Subject: ENERGY STAR Version 7 Draft 1 Displays Specification

This letter comprises the comments of the Pacific Gas and Electric Company (PG&E), San Diego Gas and Electric (SDG&E), Southern California Gas Company (SCG), and Southern California Edison (SCE) in response to the U.S. Environmental Protection Agency's (EPA) ENERGY STAR Version 7 Draft 1 Displays Specification.

Figure 1 Computer Monitor 2015 U.S. Shipments

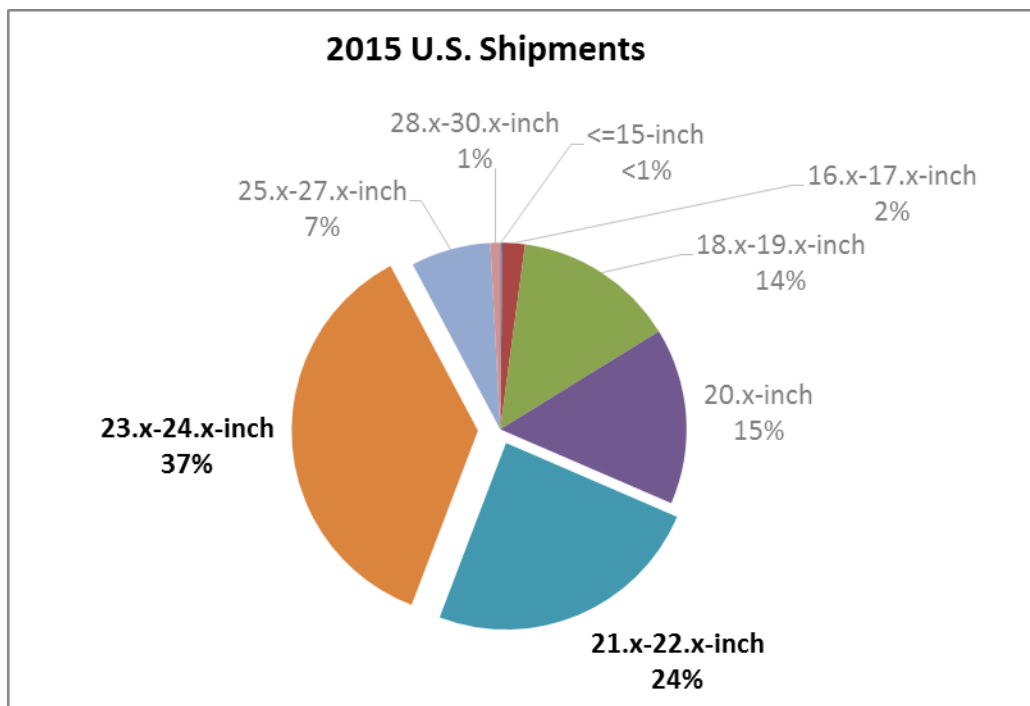
In order to target 10-15% of the current dataset instead of 20%, EPA should focus on establishing more stringent On Mode levels for the size categories of computer monitors that are a majority of the market: 21- and 24-inches. These size categories currently comprise over 60% of the total US shipments of computer monitors in the U.S. and are projected to remain over 60% in the coming years, based on market shipment information from IHS iSuppli displayed in Figure 1.

- a) **EPA should ensure that the On Mode power requirements in Version 7 represent the most efficient 25% of the market when the specification takes effect. Therefore EPA should target the top 10-15% of the current dataset to account for the rapid development cycles of this product category. EPA should propose more stringent On Mode requirements for computer monitors with a diagonal screen size between 21- and 24-inches.**

Figure 2. Draft 1 Dataset: 2.07 Megapixel Models

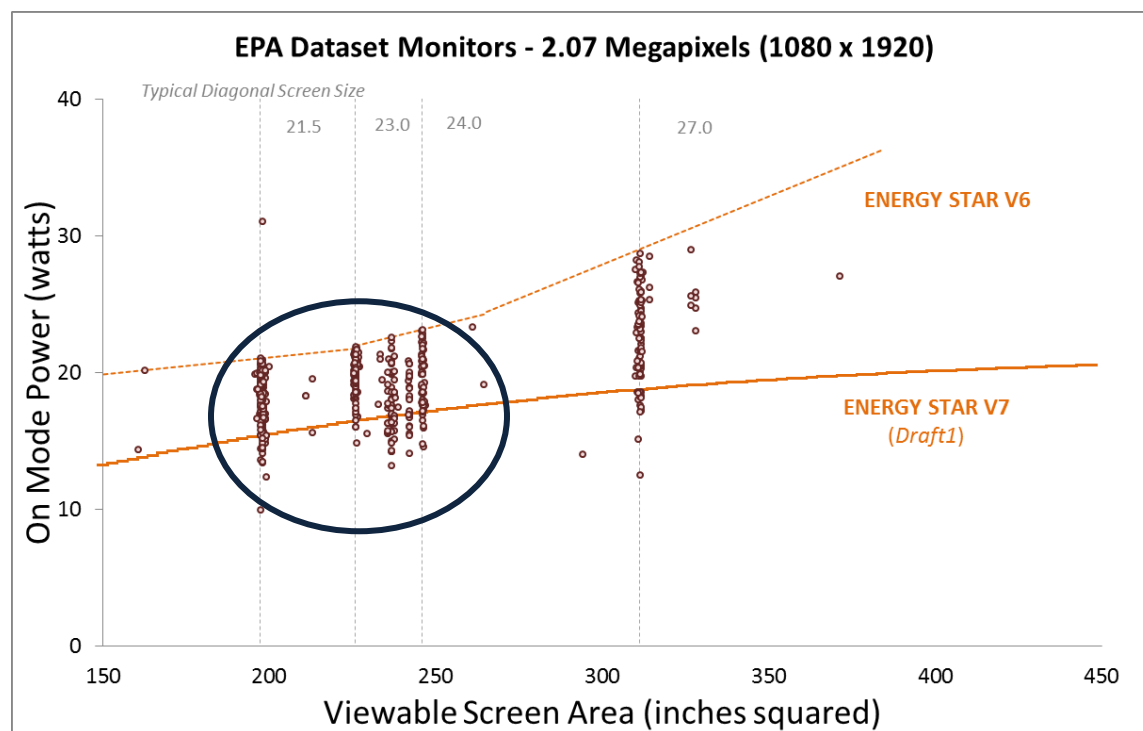
Because these size categories will account for a majority of the computer monitor shipments in 2016, EPA should consider adjusting the Version 7 On Mode requirements for models to reduce the percentage of current models that can meet the requirements in the dataset (shown in Figure 2). EPA should keep in mind, once the Version 7 On Mode requirements are finalized, manufacturers will have nine months to redesign their equipment to meet the levels. Setting On Mode levels for 21- to 24-inch models slightly more stringent would improve the likelihood that when the specification goes into effect, the ENERGY STAR label delivers upon its promise to consumers of actually differentiating the most energy efficient products in the market.

Figure 3 Signage Displays 2016 North American Shipments

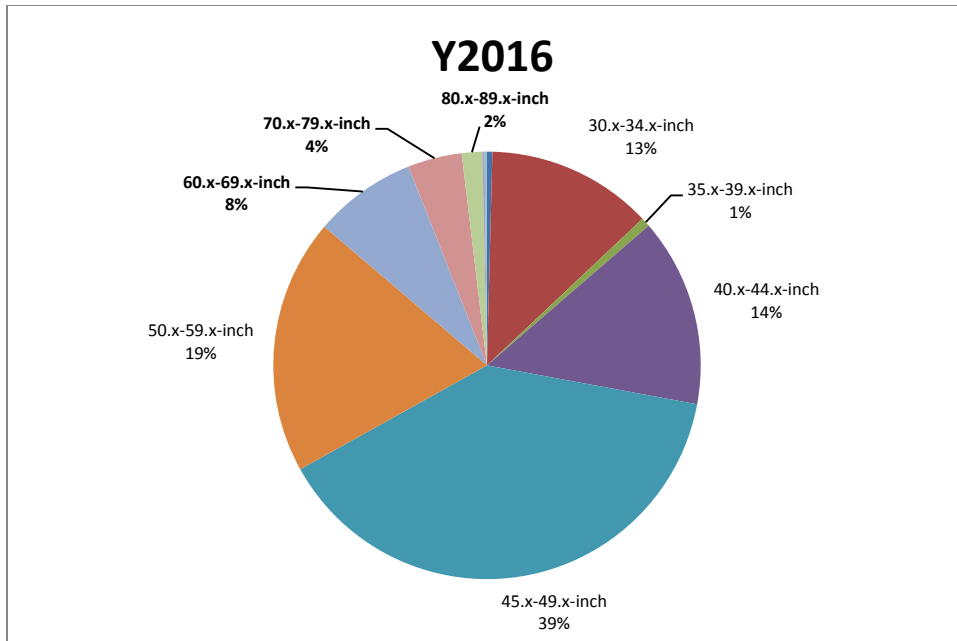
Given that a significant percentage of signage display shipments in North America are 60-inches or greater (approximately 14% of total shipment), we strongly support the scope expansion to include signage displays greater than 61-inches. Figure 3 shows projected North American shipments of signage displays in 2016. It is important to note that the total shipments of these large signage displays are also projected to increase in the coming years so we support ENERGY STAR including these products to incentivize the implementation of energy saving technologies for these large power-consuming models.

Figure 4 On Mode Limits: Draft 1 Proposal

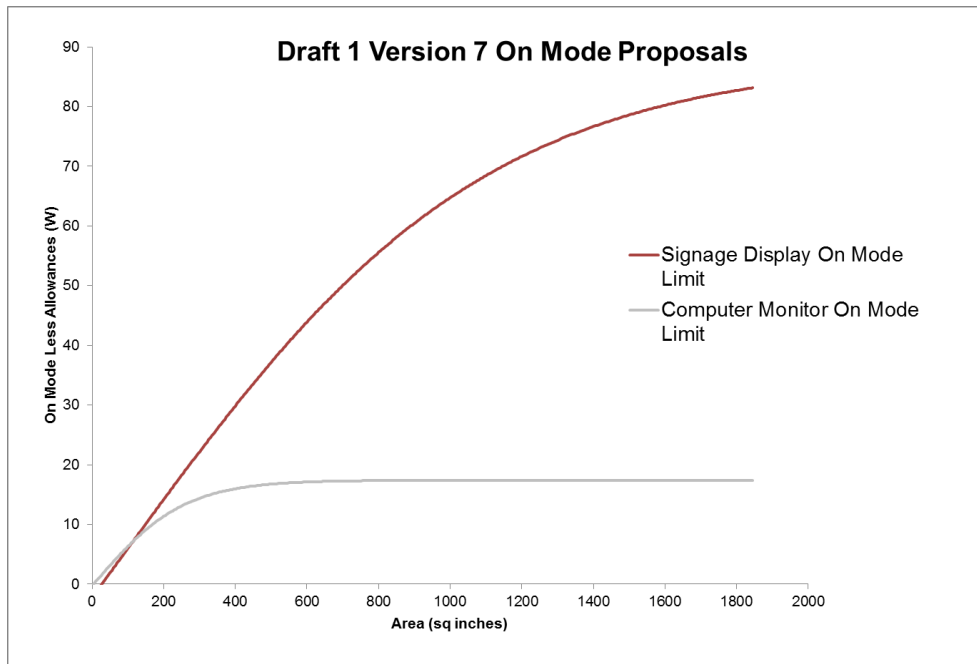
Given the drastically different On Mode requirements for computer monitors and signage displays, as shown in Figure 4, it is crucial that the product categories are properly defined with no room for misinterpretation such that a computer monitor could be subject to the signage display requirements.
